ADEQUACY OF STATION ELECTRIC DISTRIBUTION SYSTEM  
VOLTAGES, NORTH ANNA POWER STATION, UNIT NOS. 1 AND 2

Report No. EGG-EA-5927

Selected Operating Reactors Issues Program (III)

This EG&G Idaho, Inc., report reviews the capacity and the capability of the onsite power distribution system at the North Anna Power Station, in conjunction with the offsite power sources, to automatically start and continuously operate all required safety-related loads.

NORTH ANNA  
STATION ONE LINE DIAGRAM  
FIGURE 1

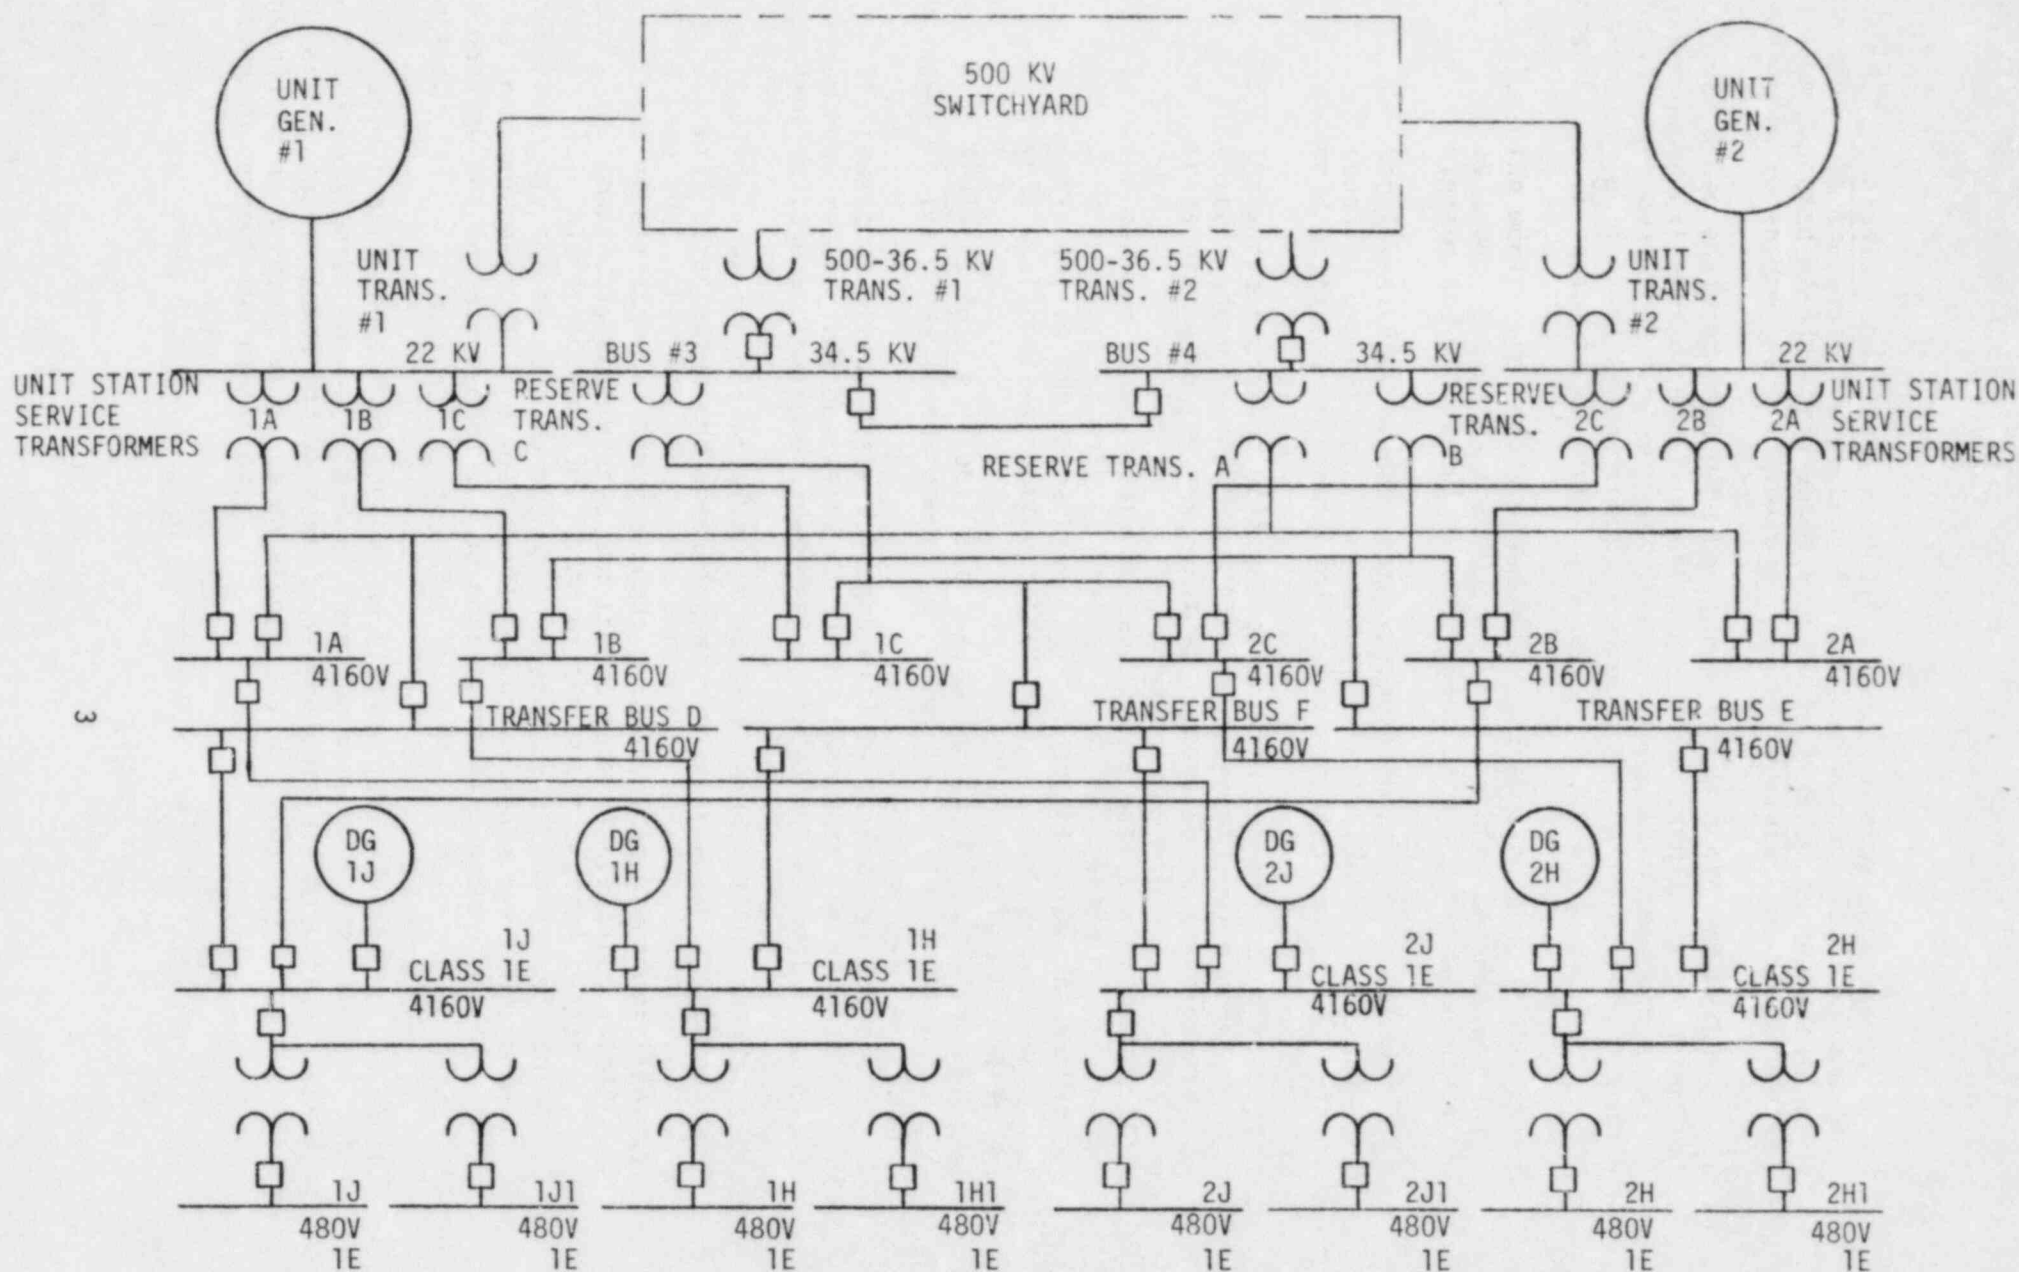
Figure 1 shows the electrical distribution system at the North Anna Power Station. Each unit has two 4160V Class 1E buses. These are designated 1J, 1H, 2J and 2H. Each of these buses provides 4160V power to high horsepower safety-related equipment and to two 4160V/480V transformers for safety-related equipment that requires less power. 480V Motor Control Center (MCC) loads have individual 460V/115V control power transformers. The breaker control circuits for the 4160V and the 480V buses are supplied power by the DC power distribution system, and thus are independent of this review. 115 VAC vital loads and instrumentation are supplied power from uninterruptable power supplies (DC backed). Should these power supplies fail, self-regulating transformers provide a stable (to within 2%) voltage.

With the completion of planned modifications (see Section 4.1), the 4160V Class 1E buses will be supplied power from the following sources: Bus 1J will normally be powered by reserve transformer A via transfer bus D. Alternately, a manually established connection to Unit 2 bus 2B is possible, with either the Unit 2 generator or reserve transformer B as its source. Bus 1H will normally be powered by reserve transformer C via transfer bus F. Alternately, a manually established connection to bus 1B is possible, with the Unit 1 main generator or main transformer being its preferred source. Bus 2J will also be normally powered by reserve transformer C via transfer bus F. Alternately, a manually established connection to bus 1A is possible, with the Unit 1 main generator or main transformer being its preferred source, or reserve transformer A as an alternate source. Bus 2H will be normally powered by reserve transformer B via transfer bus E. Alternately, a manually established connection to bus 2C is possible. This bus derives power from the Unit 2 generator, or reserve transformer C. Thus, it is possible, for buses 1H, 2J and 2H to be powered by reserve transformer C. VEPCO has proposed operating restrictions that prevent more than two of these buses being connected to this transformer simultaneously. There are no automatic transfers of these buses between offsite power sources.
